**Comments on the validation of
Thoothukudi Thermal Power Project, India
06 May 2011**

CDM Watch respectfully submits the following comment on the Project Design Document (PDD) for “Thoothukudi Thermal Power Project”, India. We highlight the importance of recognizing the integral role of transparency in the CDM validation process, and for taking this comment into consideration.

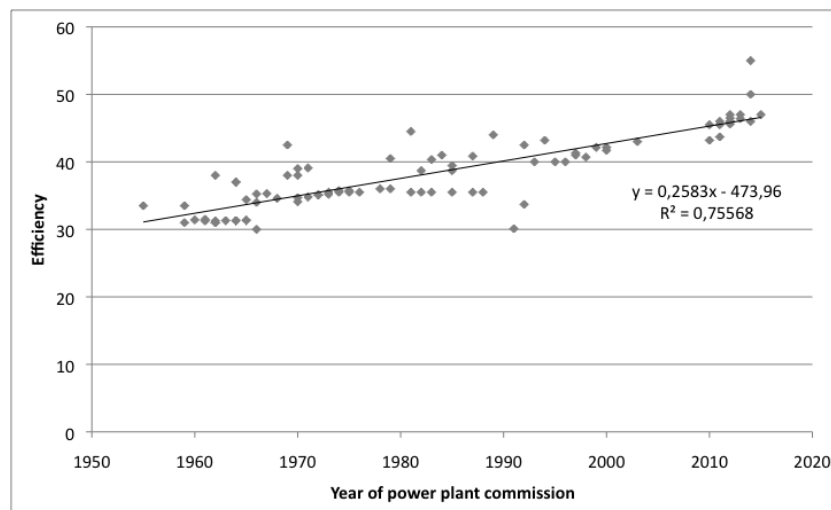
- The figure below from IEA (2008b, page 51) illustrates the efficiency improvements achieved in coal fired power plants in China. The figure shows that power plants between 100 and 400 MW, constructed in the last 10 years are 5-6% more efficient than power plants constructed in the ten years previously. This results in efficiency gains of 0.5% to 0.6% per year for power plants built in the most recent decade. The figure also shows that the improvements vary with the size of power plants and over time.

Against the above said, project developers must show how the project takes the baseline efficiency improvement into account.
